PUBLIC INTEREST TECHNICAL REVIEW FOR GROUNDWATER APPLICATIONS

TO: Water Rights Section Date: 8/13/2026
FROM: Groundwater Section J. Hackett
Reviewer's Name
SUBJECT: Application LL - 2032 Supersedes review of _____

Applicant's Name: Barnett Estate County: Sherman

Well Statistics – Irrigation wells in Township 1N / Range 17E

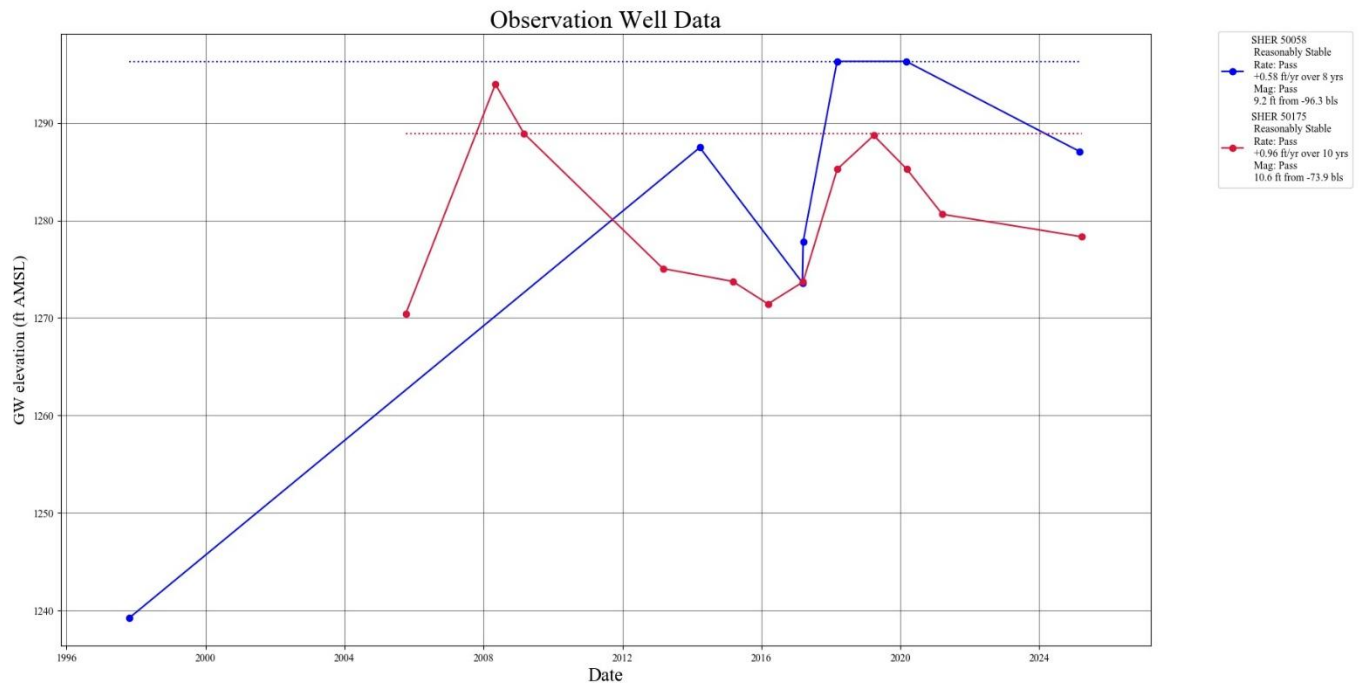
Comments: Well log data for irrigation wells in 1N/17E show a maximum yield of 640 gpm and a median of 278 gpm. These yields indicate the total requested rate is obtainable by the expected yield of the proposed POA (see attached well statistics).

Water-Level Measurements in Nearby Wells: Reasonably Stable Water Levels Evaluation

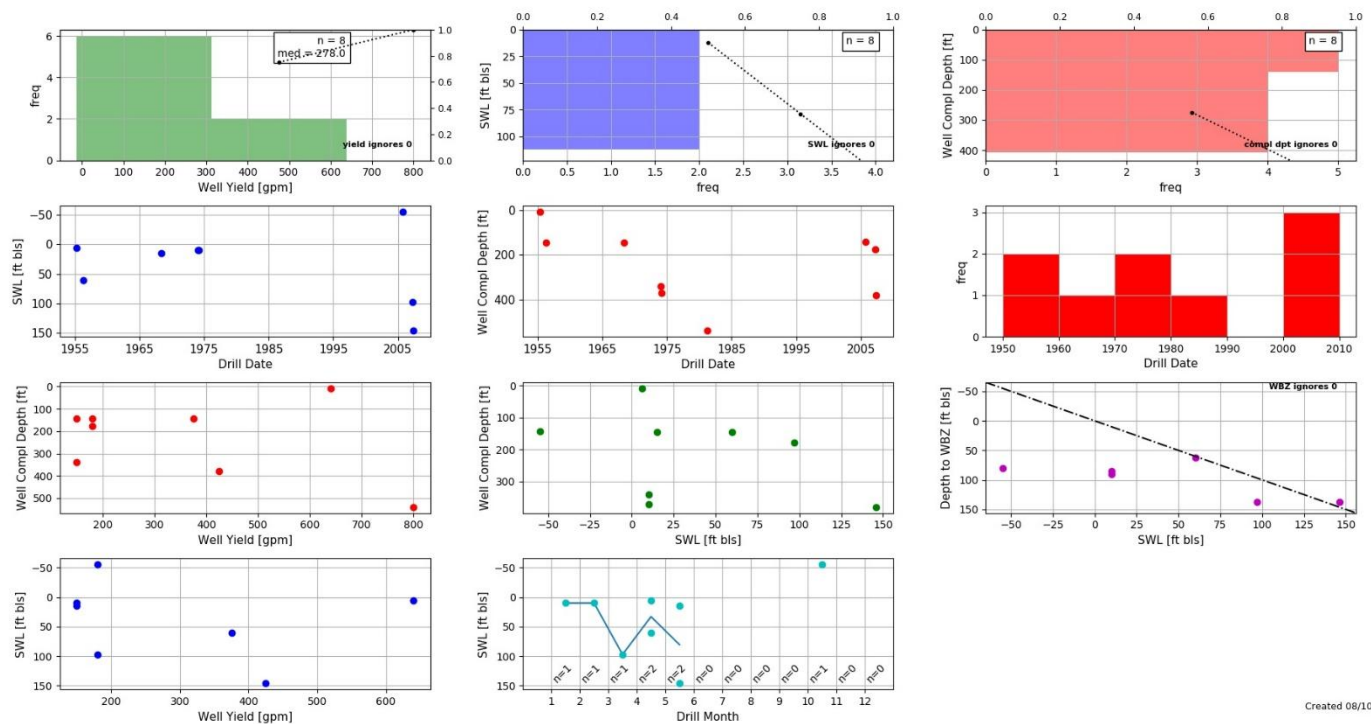
Comments: Water level data in proposed POA SHER 50175 was assessed for Reasonably Stable Groundwater Levels (RSGL). The well passed both the rate and magnitude tests, indicating water levels are reasonably stable.
